APPLICATION FOR HOUSEHOLDER PLANNING PERMISSION DELEGATED REPORT

APPLICATION REFERENCE:	PL/2026/03695
APPLICATION TYPE:	Householder planning permission
SITE ADDRESS:	Glendower, Dinton Road, Fovant, Salisbury, SP3 5JW
DEVELOPMENT DESCRIPTION:	Replace the roof with a steeper pitch brought out to gables to provide two bedrooms and a bathroom at first floor level. Internal alterations.
RECOMMENDATION:	That Planning Permission be GRANTED

Original submission

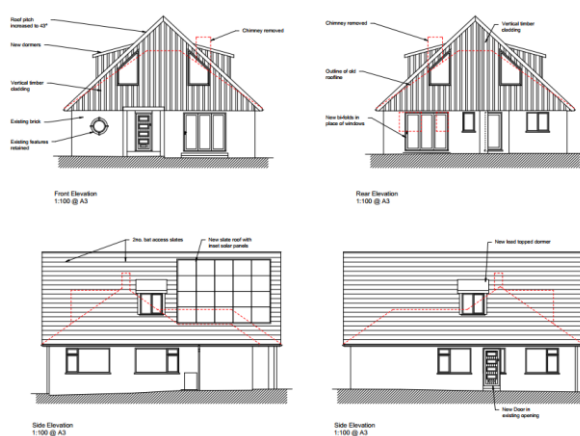
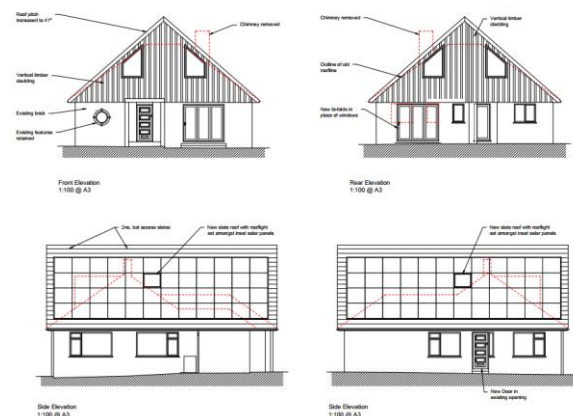
Fovant Parish Council's concern is focused on the proposed rooflights and their likely effect on the dark-sky quality, night-time landscape character and visual tranquillity of the Cranborne Chase International Dark Sky Reserve.

This proposal is especially sensitive because the two Velux rooflights would introduce direct upward and outward light escape from an elevated roof plane. Unlike low-level, downward-directed lighting, rooflights can glow visibly after dusk, contributing to skyglow and weakening the rural darkness that the International Dark Sky Reserve is intended to protect.

The substantially higher and elongated increased ridge level will impact our outlook but the greater concern is the effect on our privacy both from the dormer window to the North and the rear 1st floor windows which will directly overlook our rear garden. Further concern is that should this application be approved it will set a precedent for future development along Dinton Road.

We have looked at the revised plans and whilst the change from dormer windows to rooflights does mitigate some of the privacy issues the fact the proposed front & rear windows remain the same means that they overlook both our front garden & especially the rear garden. The proposed size & height of the roof remains the same and the addition of a substantial number of solar panels does nothing to enhance our outlook or indeed the detrimental impact that such a large construction would have on the neighbours immediately adjacent to the properties and others close by including ourselves.

During the course of the application, revised plans were sought to reduce the pitch of the roof and lower the ridge height. A street scene elevation was also requested to enable a full assessment of the proposal within its immediate context and in relation to neighbouring properties.

The revised proposal would result in a ridge height approximately 1.5 metres higher than the existing highest point of the roof. No increase in the building footprint is proposed and no dormer windows are included within the side elevations. Having regard to the reduced ridge height and the relationship with neighbouring dwellings, the resulting scale, bulk and massing of the development is not considered disproportionate to either the existing dwelling or its plot. The proposal would not appear unduly dominant or incongruous within the street scene such that a refusal could be reasonably justified on design grounds.

Concerns have been raised by Fovant Parish Council regarding potential light spill from the two proposed rooflights and the contribution this may make to the International Dark Sky Reserve. The original proposals included for a dormer window on each roof slope, these were omitted during the course of the application due to concerns regarding overlooking of the adjacent neighbours. These windows were replaced with rooflights, these have the potential to impact on the dark skies of the National Landscape. The proposed rooflights serve the first floor landing and a shower room.

The revised proposals remove dormer windows on the southeast and northwest roof slopes, replacing them with rooflights. These rooflights serve a shower room and a landing, which are non-habitable rooms and are not considered to increase overlooking and are therefore acceptable.
